NRL Report No. R-2093
BuShips Prob. X71S

TESTS OF THE MODEL SF RADAR

Contractor - The Submarine Signal Co.

NAVAL RESEARCH LABORATORY
ANACOSTIA STATION
WASHINGTON, D. C.

PLATE 103 SEC. 3

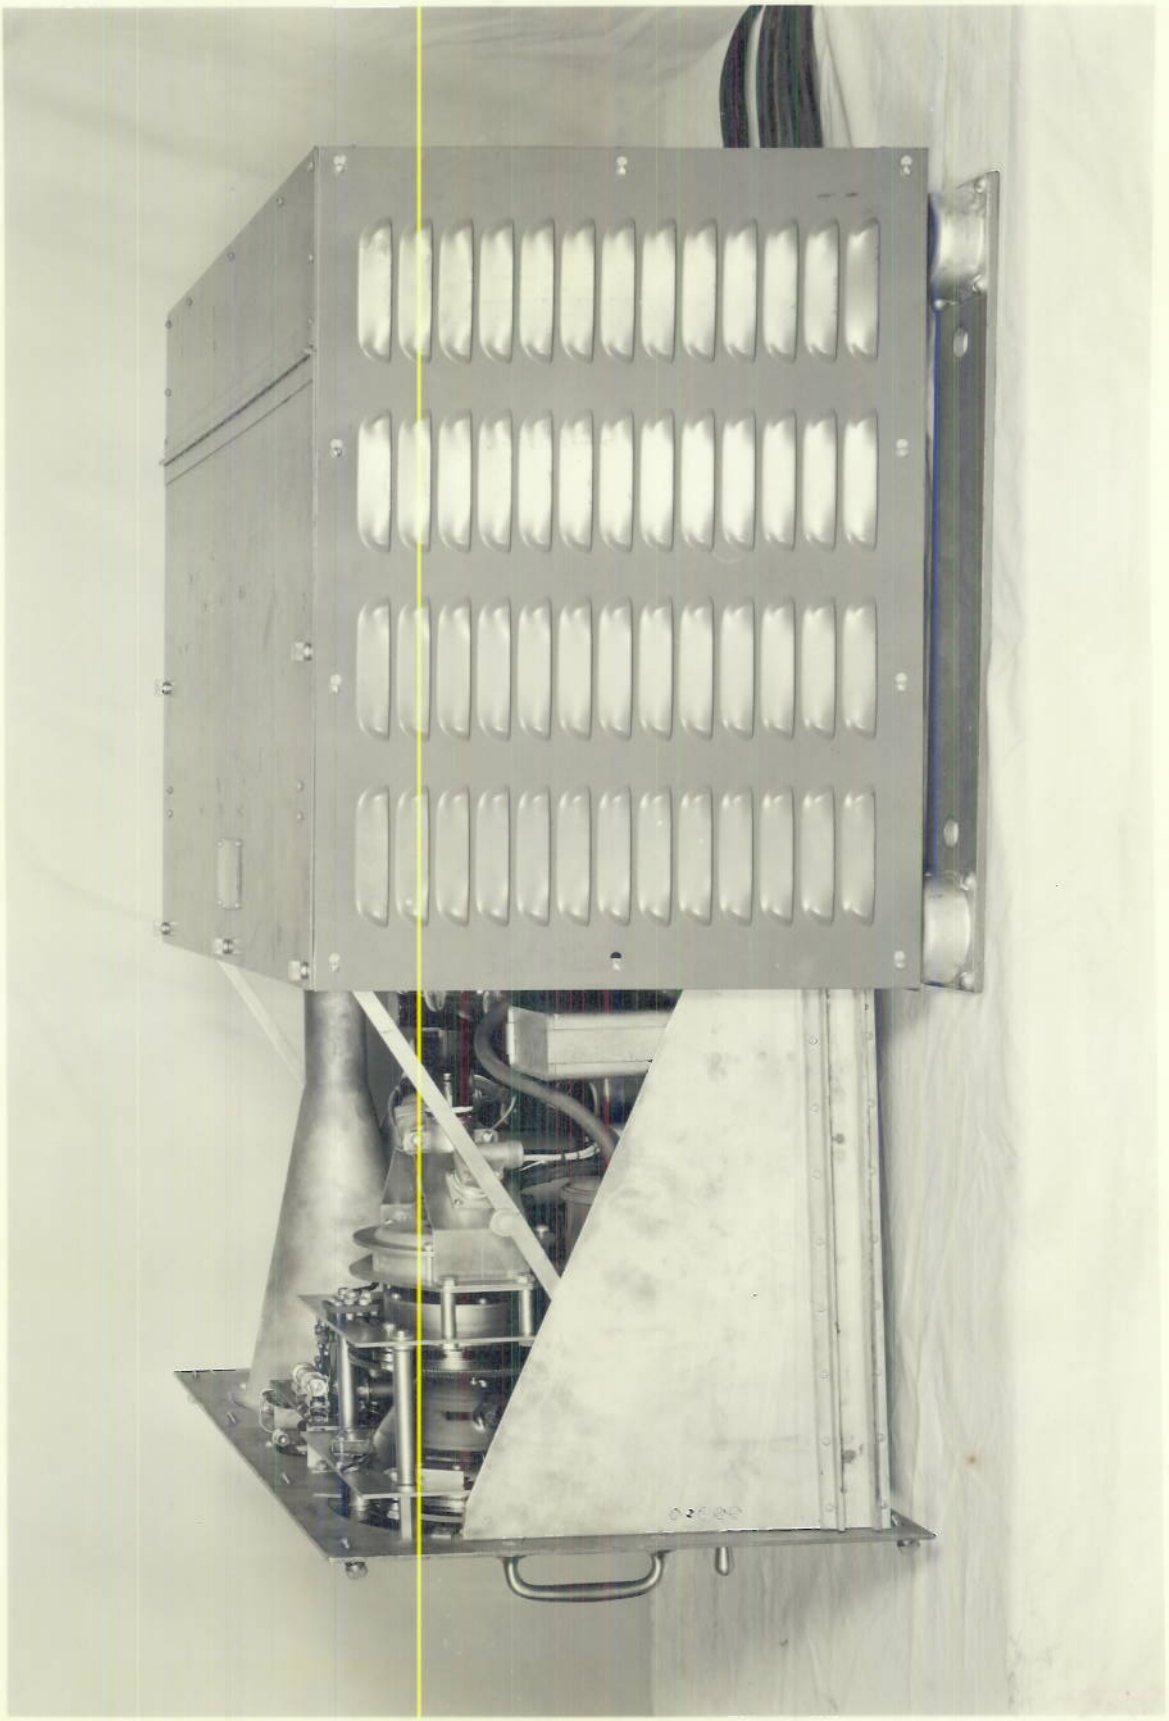
The construction of the frame, cabinet and chassis of the receiver-indicator is sturdy. However, the chassis locks of the present equipment will not permit the removal of the chassis by more than four inches. It is necessary to remove a vacuum tube and to spring aside one of the locking arms before the chassis can be pulled out. In this position it is extended three quarters of its total length. However, the i-f sub-chassis and a number of components remain inaccessible. See plate 103.

PLATE 104 SEC. 3

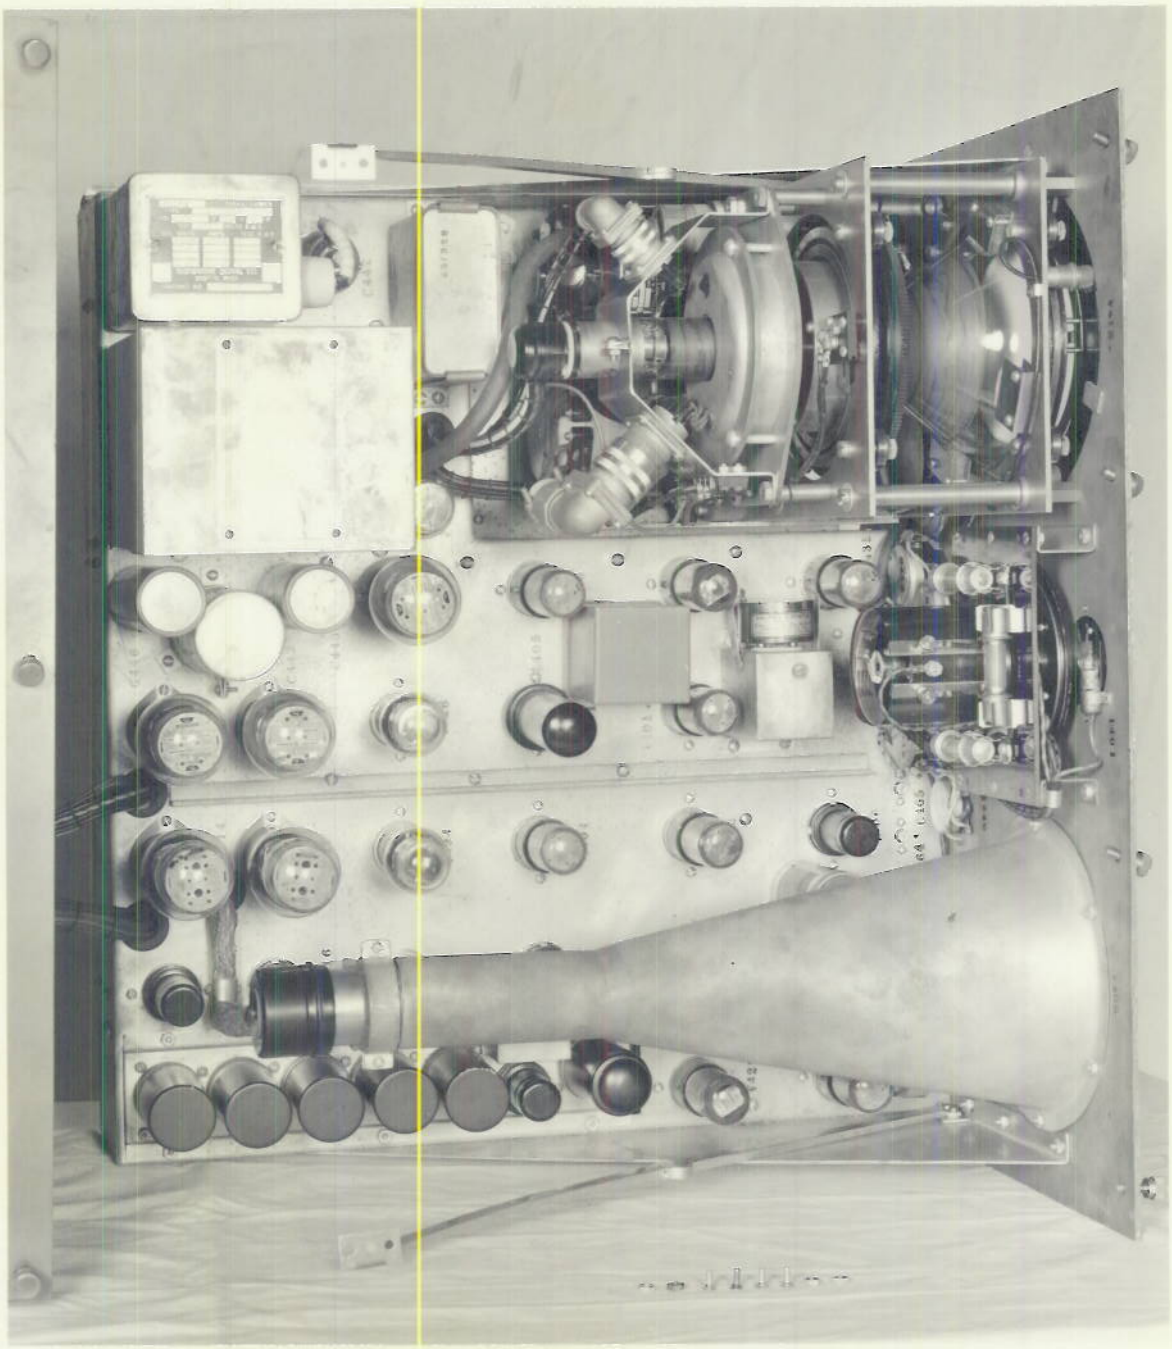
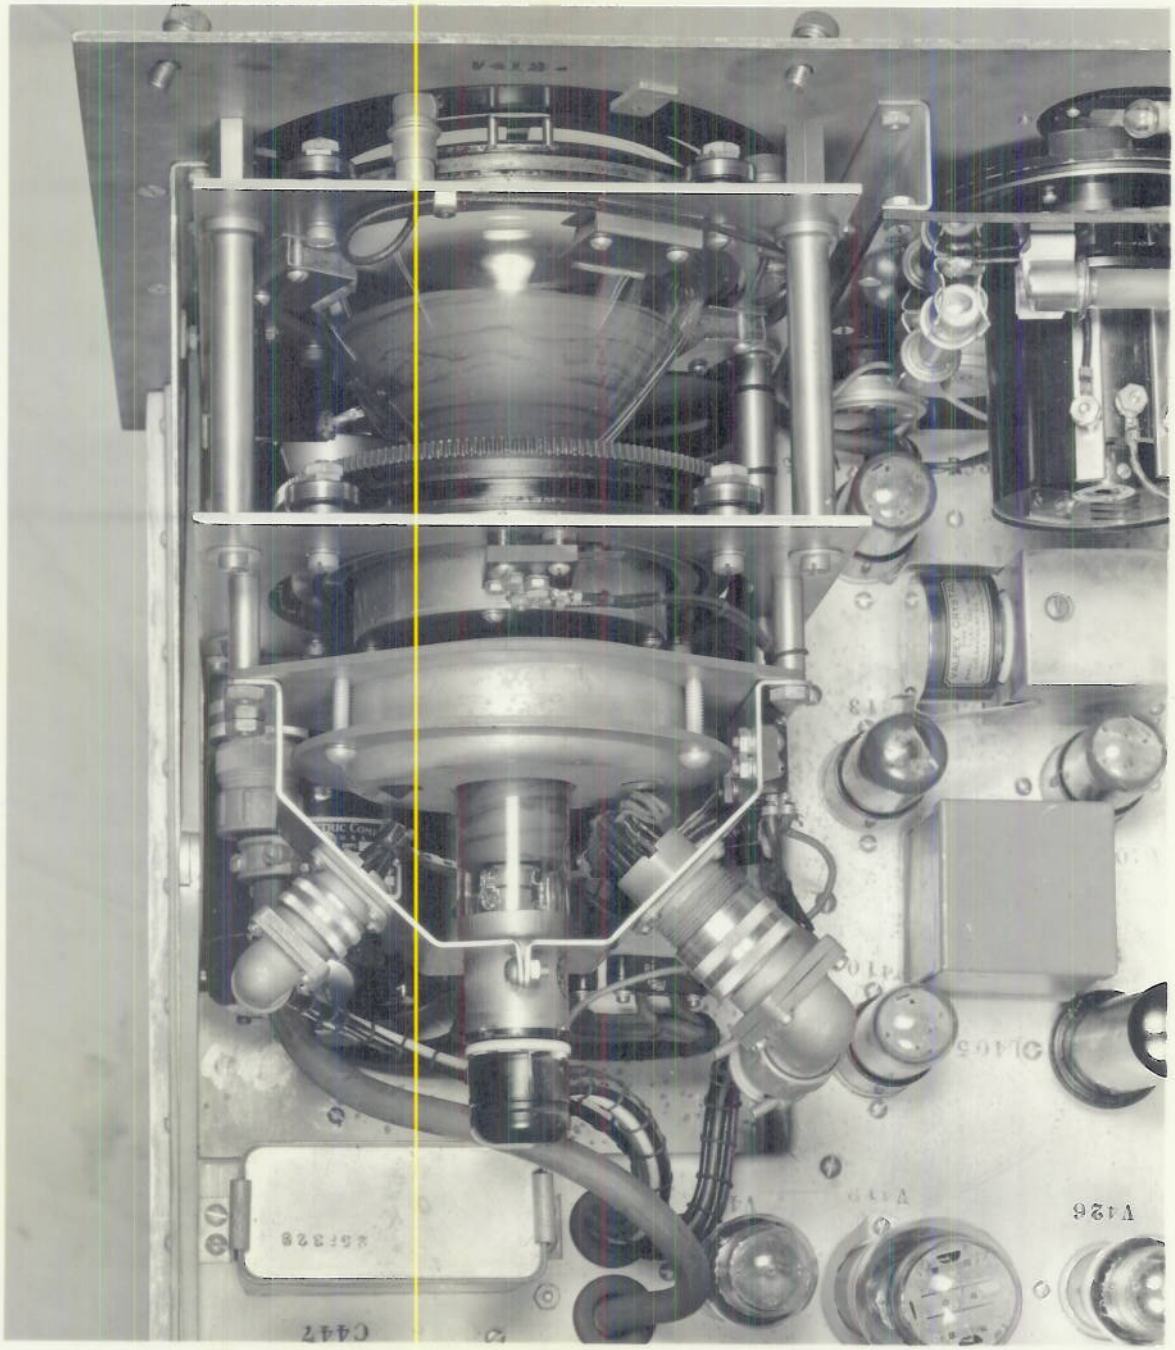
3-9-9. It would be desirable to change the mechanical design of the clamp that secures the base of the PPI tube so as to allow the replacement of this tube by loosening one screw rather than the four which is now necessary. See plates 104 and 105.
